ADDENDUM NO. 1 - REV

August 2, 2024

READING REGIONAL AIRPORT

MULTIPLE BUILDING RENOVATIONS

1 SLAB REPAIR PLAN

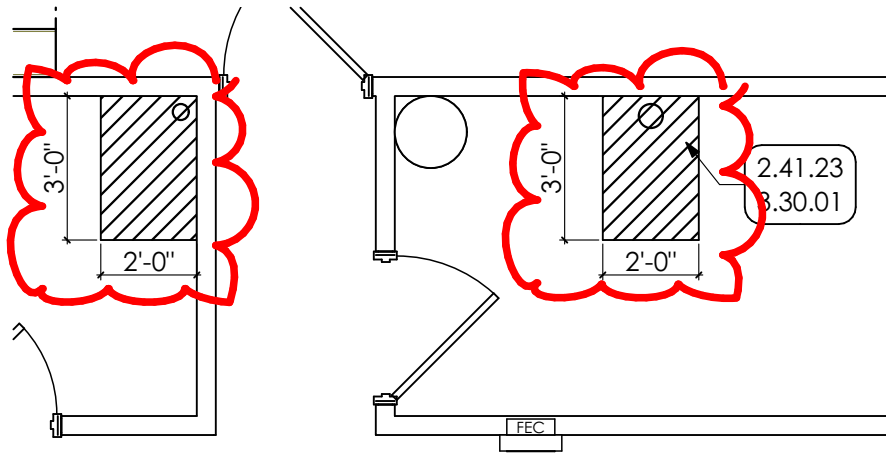
1. **Sheet A-001: MODIFY** DEMOLITION NOTES, Note No. 14, remove the reference to “structural drawings”.
2. **Sheet A-102: Drawing 1: MODIFY** slab repair plan to include dimensions for the repair area. See attached SD-001, which is attached to and made part of this addendum.

REFLECTED CEILING PLAN

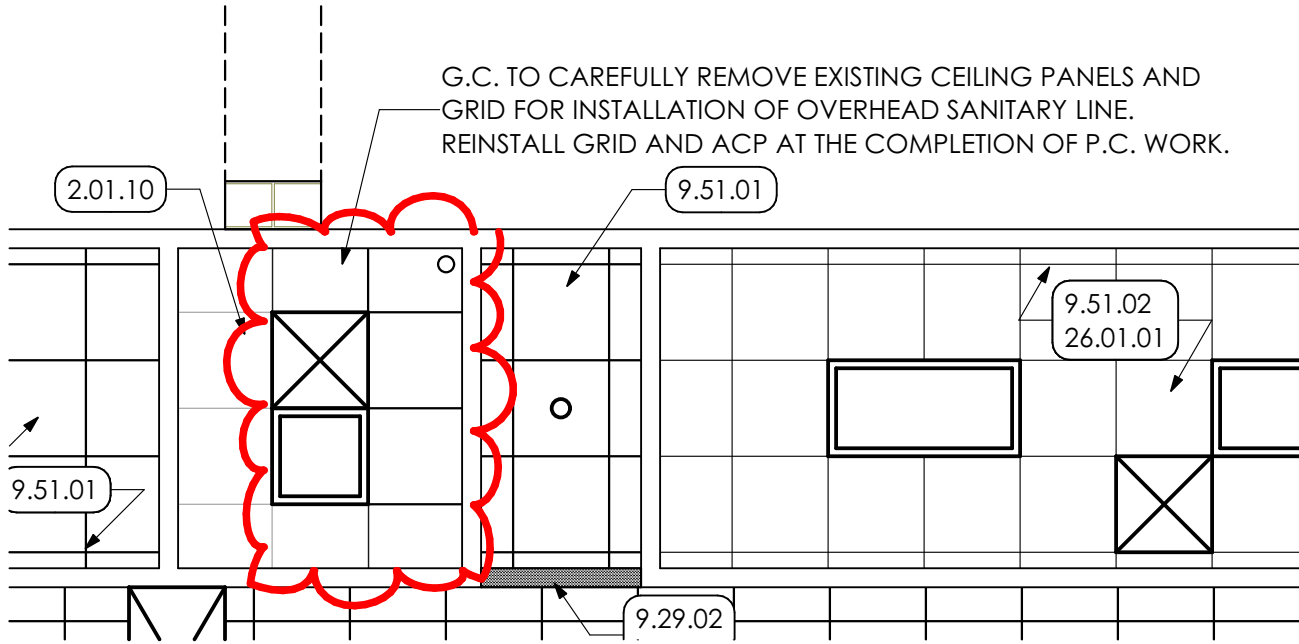
7. **Sheet A-106: Drawing 1: MODIFY** reflected ceiling plan to show area of ceiling to be carefully removed and reinstalled by General Contractor. See attached SD-002, which is attached to and made part of this addendum.
